# Modified 600 Tank Farm Road Project

Addendum to the Environmental Impact Report

**February 2025**

Access Evaluation for the Modified 600 Tank Farm Road Project

Figure 3 Interim Transportation Improvements Design Concept

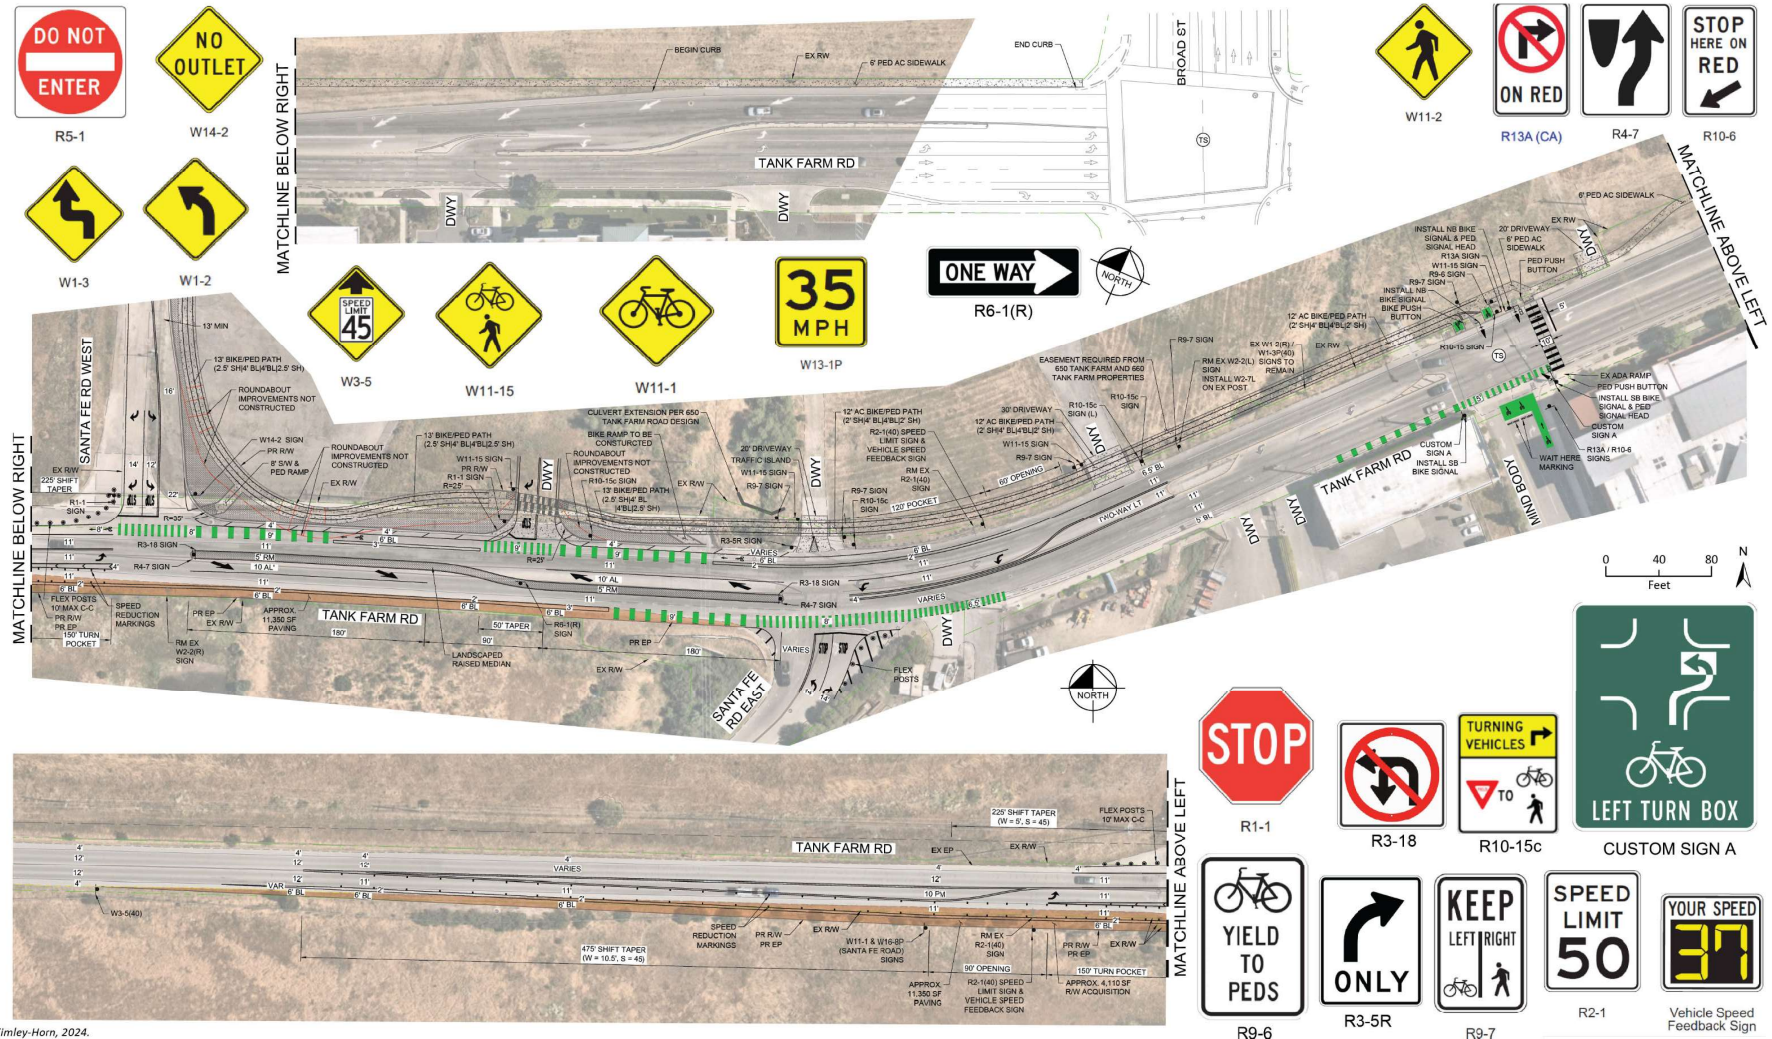
The modified project would eliminate the previously planned roundabout at the intersection of Tank Farm Road and Santa Fe Road, replacing this project component with a modified/interim access design concept that would provide access to the project site without the roundabout until it can be built in the future by the City or other private development. Key features of the interim transportation improvements include:

- Tank Farm Road/Santa Fe Road (West) Intersection: Unsignalized, with stop control on the Santa Fe Road (West) approach.
- Minor Road Widening on Tank Farm Road: Widening to add an eastbound left-turn lane into Santa Fe Road (West) and buffered on-street bike lanes along Tank Farm Road.

- Frontage Improvements:
  - Santa Fe Road (West): Landscaped parkway, lighting, street trees, and an elevated (sidewalk-level) two-way shared-use pedestrian/bicycle on the east side of street only. The shared-use path is to be constructed with permanent materials (concrete) and designed with flexibility to convert to a separate pedestrian sidewalk and one-way northbound protected bike lane in the future by others.

- Tank Farm Road: Landscaped parkway, lighting, street trees and a two-way shared-use path between Santa Fe (West) and the Mindbody traffic signal. Shared-use path constructed in permanent materials (concrete) along 600 Tank Farm Road frontage, and with temporary (asphalt) east of frontage to Mindbody signal. The shared-use path is to be designed with flexibility to convert to a separate sidewalk and one-way westbound protected bike lane in the future by others. Tank Farm Road improvements also include widening of the existing culvert at Acacia Creek.

- Temporary Sidewalk: Asphalt sidewalk on street-level along the north side of Tank Farm Road from the Mindbody signal to Broad Street with a protective curb separating pedestrians from vehicle traffic.

- Traffic Safety Features: Landscaped center median along Tank Farm Road frontage to prevent illegal left turns, acceleration lanes to improve left-turn access to Tank Farm Road from southbound Santa Fe (West) and northbound Santa Fe (East), radar speed feedback signs, striping and warning signage to encourage safer speeds.

- Signal Modifications: Updates to the Tank Farm Road/Mindbody intersection to add pedestrian and bicycle signals phases and bicycle left turn box to improve Tank Farm Road crossings.

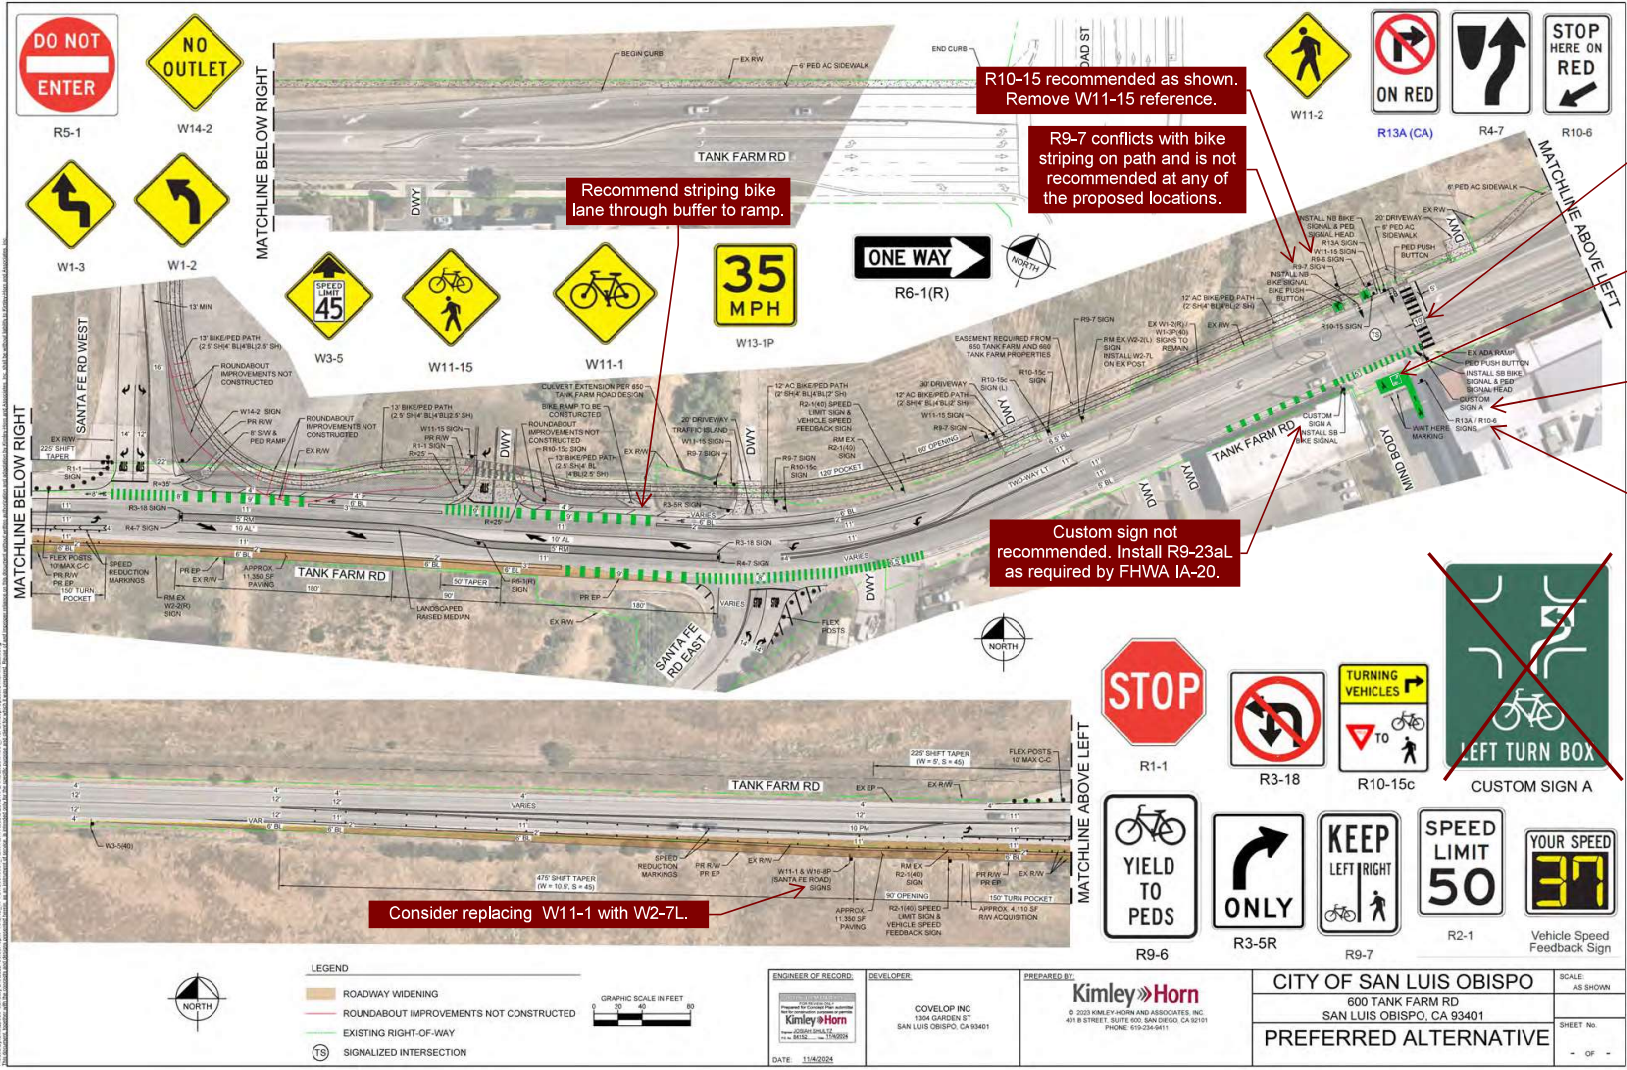
R10-15 recommended as shown. Remove W11-15 reference.

Replace existing mast arm sign with R3-18.

Replace symbol in front of right turn lane with a two-stage turn box as required by FHWA IA-20.

Custom sign not recommended. Remove.

Add R3-7bP sign below R10-6 sign and move R13A (CA) closer to intersection consistent with FHWA IA-18.
